EXECUTIVE DEPARTMENT OFFICE OF MANAGEMENT AND BUDGET STATE PLANNING COORDINATION

October 21, 2005

RE: PLUS review – PLUS 2005-09-12; Meding Property

According to the information received, you are seeking site plan approval for 238 residential units on 106.62 acres.

Meding Property (PLUS 2005-09-12) with excellent recharge in green and affected parcels outlined in light blue.

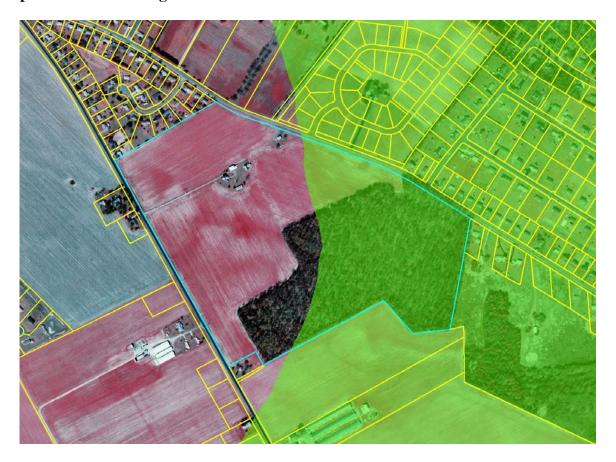
The DNREC Water Supply Section has determined that the eastern half of the property falls entirely within an area of excellent groundwater recharge (see following map and attached map).

The proposed development would change the total impervious cover 1% to approximately 25% in proposed development area. The percentages were provided by the developer on the PLUS application. The land use would change from agricultural to residential. The proposed development area impacts the excellent recharge area.

The excellent recharge area corresponds roughly with a forested area on the eastern part of the property with 22.33 acres of this naturally forested area proposed for removal. The current state of forested recharge area is ideal to replenish the local unconfined aquifer. Whatever steps can be taken to preserve this area is encouraged.

DNREC Water Supply Section recommends that that portion of the new development within the excellent recharge area not exceed 20% impervious cover. The current proposed impervious cover would exceed this threshold. Further, some allowance for augmenting ground-water recharge should be considered since the impervious cover exceeds 20% but is less than 50% of that portion of the parcel within this area.
